SERVICE BULLETIN SB-41A

SUBJECT: Tail Rotor Rigging

ROTORCRAFT AFFECTED: R44 Helicopters S/N 0001 thru 1225 except 1183, 1196, 1197, 1198, 1203, 1204, 1209 thru 1212, and 1219 thru 1224.

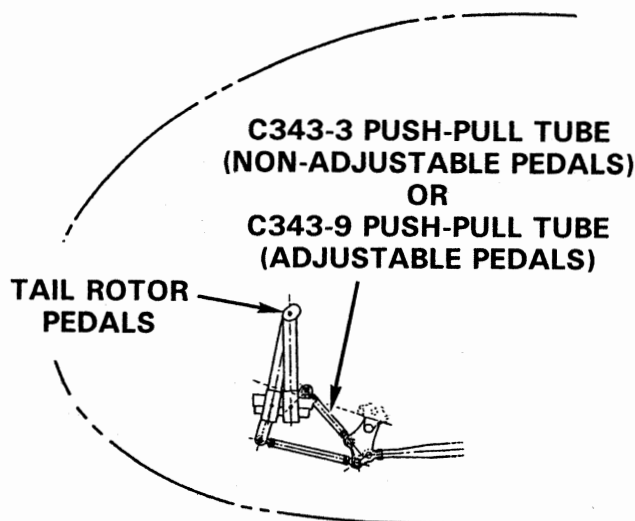
- c. Refer to figure below. Adjust C343-3 or C343-9 push-pull tube assembly per R44 MM section 10.002. Shortening C343-3 or -9 push-pull tube assembly will increase blade angles at left pedal stop. One turn of rod end increases blade angle approximately one degree for non-adjustable pedals or 1.5 degrees for adjustable pedals.

- d. After final adjustment to 18.5°~19.0° blade angle at left pedal stop, torque nut and palnut at push-pull tube rod end per R44 MM section 1.320, and torque stripe.
